**Consultation Response from KC,
Conservation & Design****2023/90332 Titanic Mill, Low Westwood Lane, Linthwaite, Huddersfield, HD7 5UN****Listed Building Consent for replacement of existing solar panels and erection of new solar panels (within a Conservation Area)****Date Responded: 06.06.2023****Responding Officer: Sebastian Pickles****Responding Ref:**

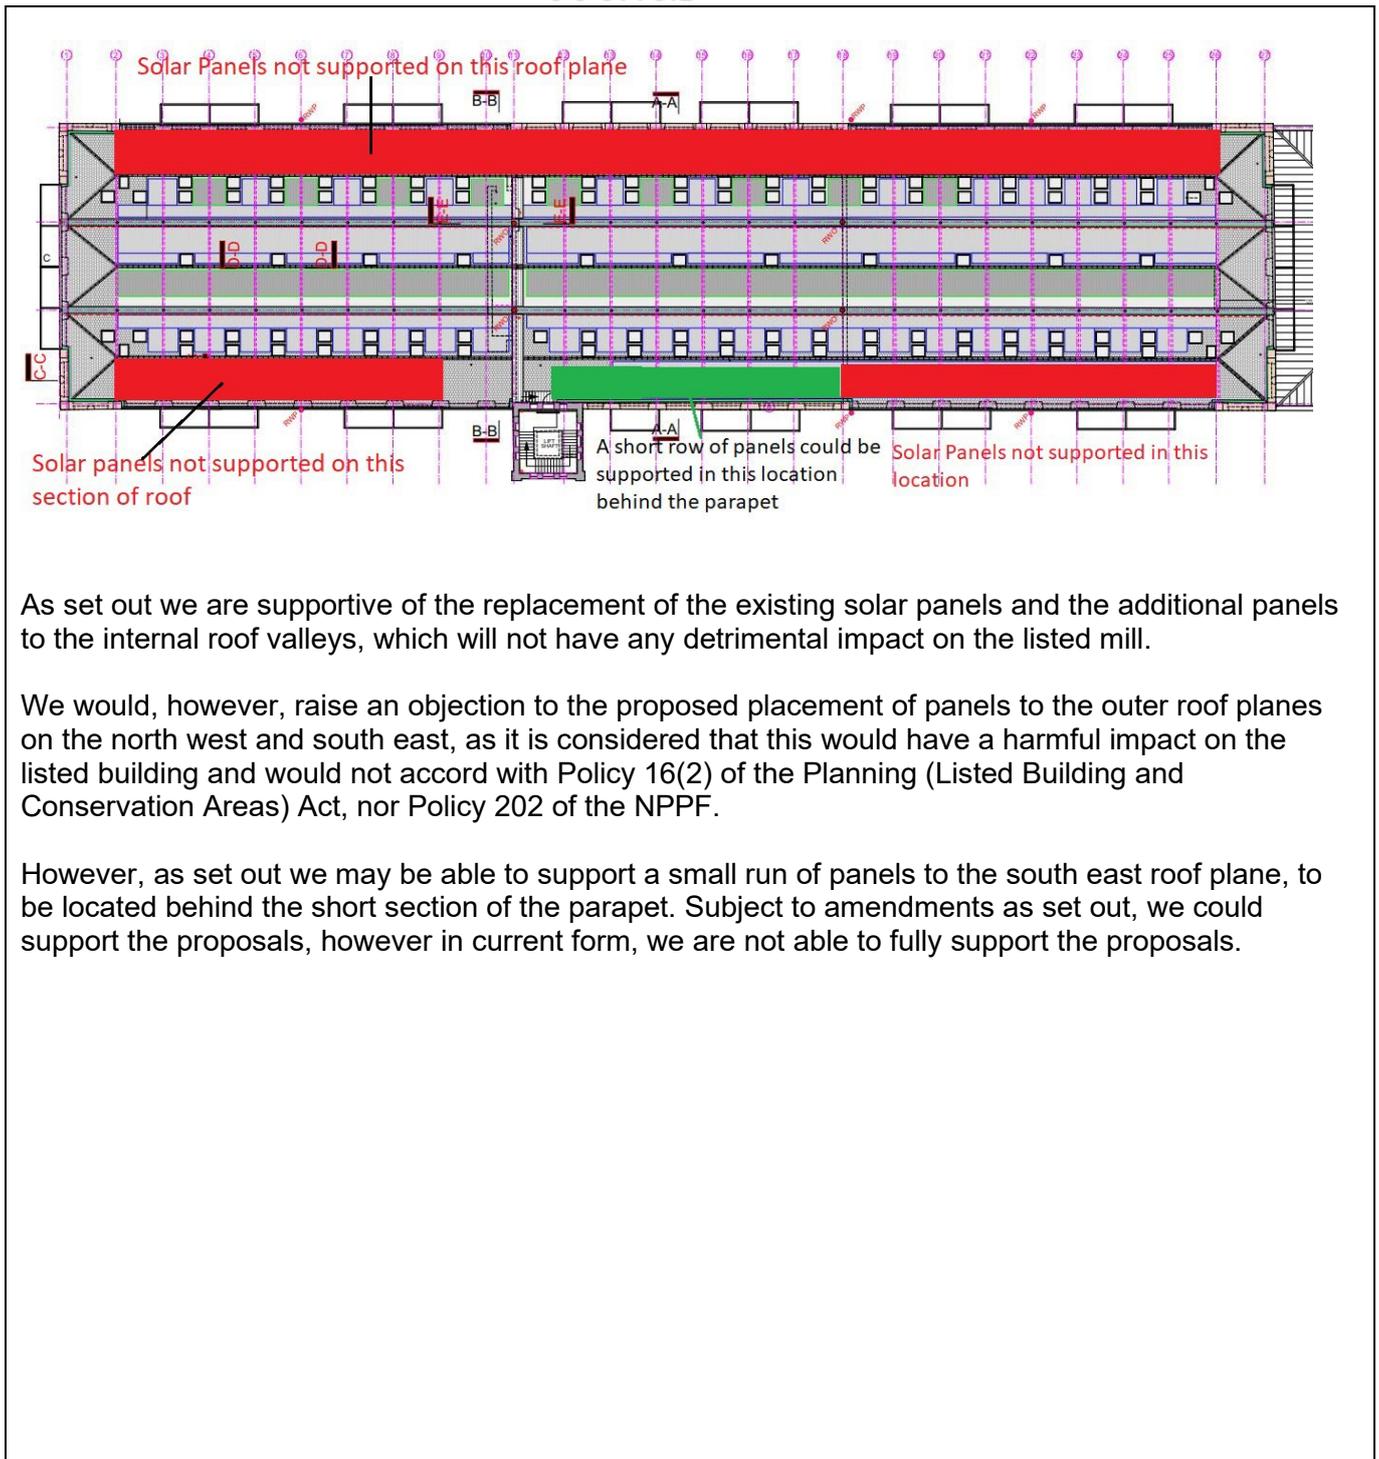
We would however raise an objection to the placement of solar panels on the north-western roof plane. Panels on this roof would be highly visible and have a harmful impact to the listed mill. While it would see the addition of some solar panels, we are not convinced that there is sufficient benefit to outweigh the harm which would be caused.

As to the south-western roof plane. This roof plane is mostly visible off Manchester Road and on the approach to the Mill down Bargate. This being said, there is one small section of the roof which has a short section of parapet to the side of the central tower. Given the parapet provides a reasonable degree of screening we consider that it would be possible to allow for a short run of panels in this location and we have indicated this on the plan below for clarity.

However, as set out we may be able to support a small run of panels to the south east roof plane, to be located behind the short section of the parapet. Subject to amendments as set out, we could support the proposals, however in current form, we are not able to fully support the proposals.
